SECTION 4.55(1A) MODIFICATION APPLICATION
Building R4B, One Sydney Harbour, Barangaroo South Sydney

This modification application has been prepared by Ethos Urban on behalf of Lendlease (Millers Point) Pty Ltd, pursuant to section 4.55(1A) of the *Environmental Planning and Assessment Act 1979* (EP&A Act) to modify Development Consent SSD 6965 relating to Building R4B Barangaroo South (the site).

Figure 1 Changes to the development boundary (outlined in red)

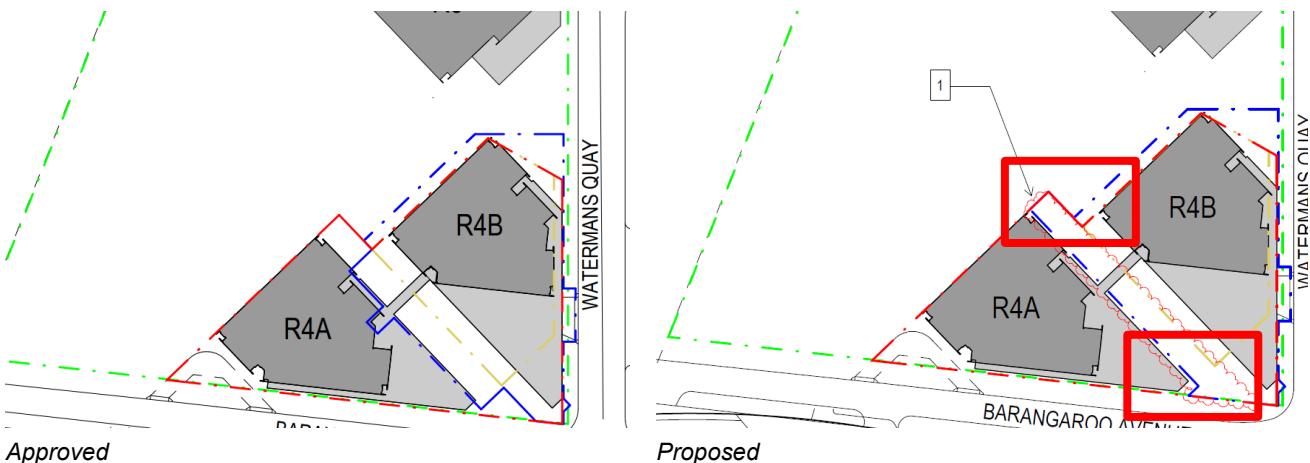
It is proposed to transfer the approved Strada, inclusive of ground plane and associate structure from the Building R4A Development Consent (SSD 6964) to the Building R4B Development Consent (SSD 6965) so that the entirety of the Strada, including the ground plan and the roof structure above it, are approved under the same development consent. Currently, the ground plane and associated wind management elements are approved under the R4A consent, and the Strada roof within the R4B consent.

The purpose of this modification is to consolidate both the ground plane and roof together under one consent which will better align the construction and delivery of the whole Strada with Building R4B, which will be complete after Building R4A. Both R4A and R4B are currently well under construction and are forecast to complete within close timeframes. The transfer of the Strada will not substantially delay its delivery, rather it will enable the efficient construction of the buildings and associated public domain.

To accommodate this amendment, the development boundary of Building R4B has also been modified to incorporate the Strada, as shown in **Figure 1**.

Figure 3 Proposed refinements to entry vestibule design, shown in red

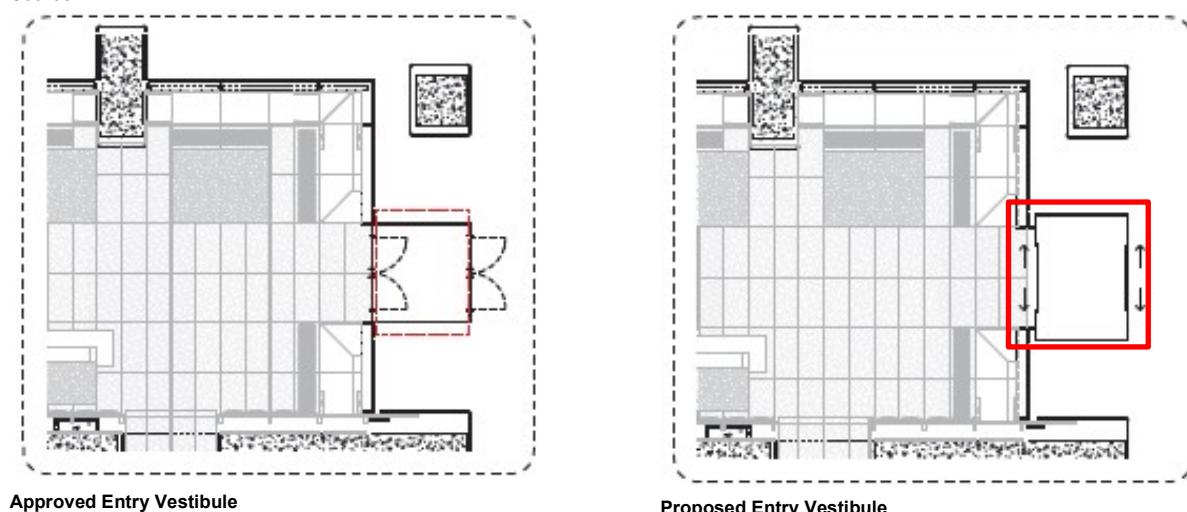
Additionally, the proposed modification includes amendments to the entry vestibule design as shown in **Figure 3**.

As a result of ongoing design development, the configuration of the entrance vestibule is proposed to be revised to provide a simplified and improved architectural response to the façade. Specifically, automated sliding doors have been integrated in lieu of swing doors, improving operation as well as creating a seamless transition from outside to the residential lobby interior.

This amendment results in a minor adjustment to the dimensions of the lobby vestibule. This amendment has been integrated into the modulation, proportion and geometry of the façade to provide a design response that meets the design standards of the precinct architecture.

Figure 4 Proposed amendments to the building identification signage zone of R4B.

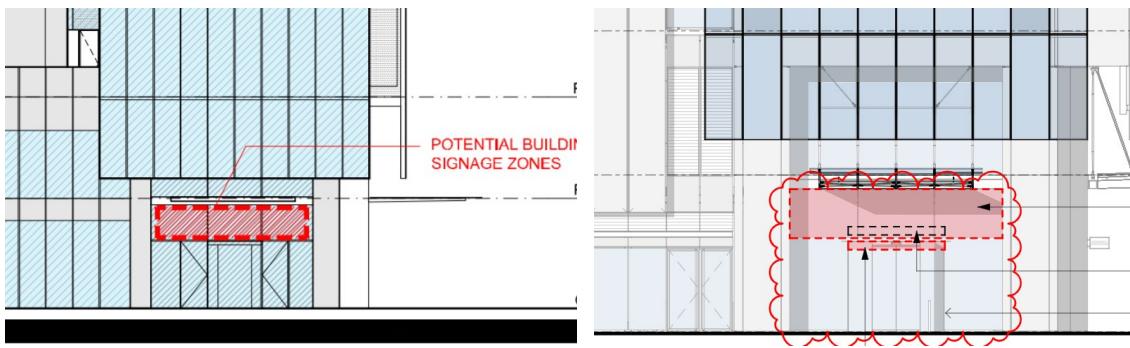
Due to the changes described above relating to the entry vestibule, minor amendments are required to the building identification signage located above the entrance. The approved signage zone encapsulates an area above the swinging doors and a section adjacent to the doors. Due to the removal of the swinging doors and further design development, three signage zones are now proposed to reflect the current arrangement. These include a zone on the upper portion of the glass entry way, on top of the glass entry way and the existing approved zone above the entrance vestibule. It is noted that whilst three signage zones are proposed, only one will be utilised for detailed signage, subject to the final design of the building.

Figure 4 below reflects these changes.

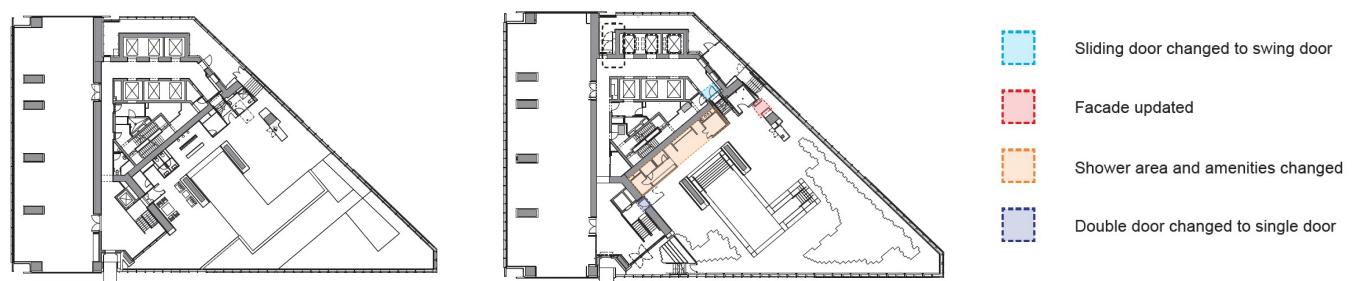
The modification proposes minor improvements to the layout of the shower and bathing amenities, the width and alignment of the portal, and changes to the door types in the accessways to the swimming pool terrace. Refer to **Figure 5** for the proposed level 2 floor plan, which illustrates the amendments to the pool area and ancillary communal facilities.

Figure 6 Proposed Vent Geometry

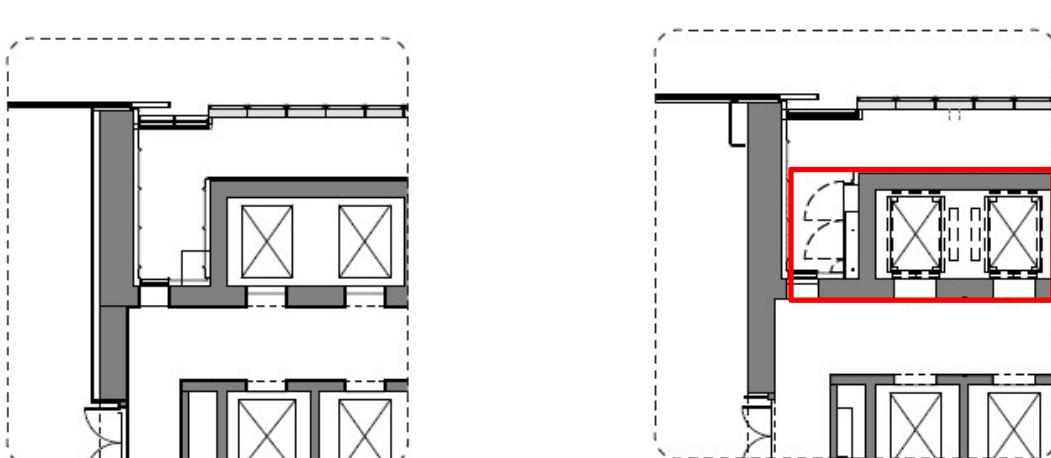
Furthermore, it is proposed to amend the vent pipes on P02 level close to the south east lift core façade, as shown in **Figure 6**. The approved box flue solution has been reworked to better reflect the design of the façade.
